## FIELD INSPECTION

<b>Project Name:</b>	Mountain Valley Pipeline	<b>Inspector:</b>	Matthew Grant
<b>Inspection Date:</b>	Tuesday, December 18, 2018	<b>Project Contact:</b>	Brian Clauto
<b>Spread:</b> Pittsylvania County MP 299-MP285 Transco	Spread I	<b>Weather (Wet/Dry/Rain):</b>	Wet

## FIELD INSPECTION PHOTO LOG

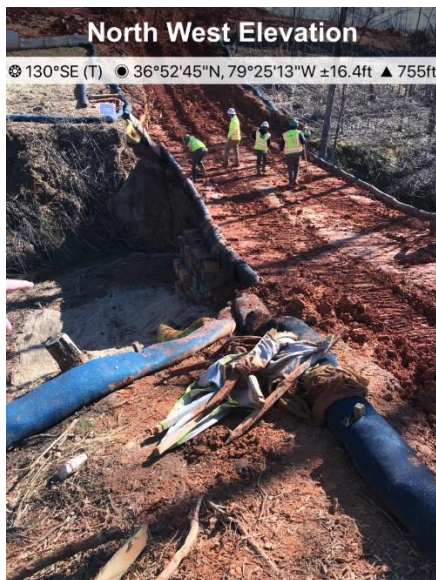
- Fig. 1 Sediment basin riser requires maintenance and re install at Transco site.

- Fig. 2 Construction entrance near St#15700 at Riddle Rd. intersection requires maintenance.

- Fig. 3 St#15700+00 designated stream SB-6 requires sediment removal.

- Fig. 4 St#15080+00 clean water plunge pool is discharging onto ROW.

**Recommended Corrective Action:** The issues noted above were added to the daily punch list on 12/18/18. Repair and maintain all controls per the approved plan, and remove sediment per DEQ approval.
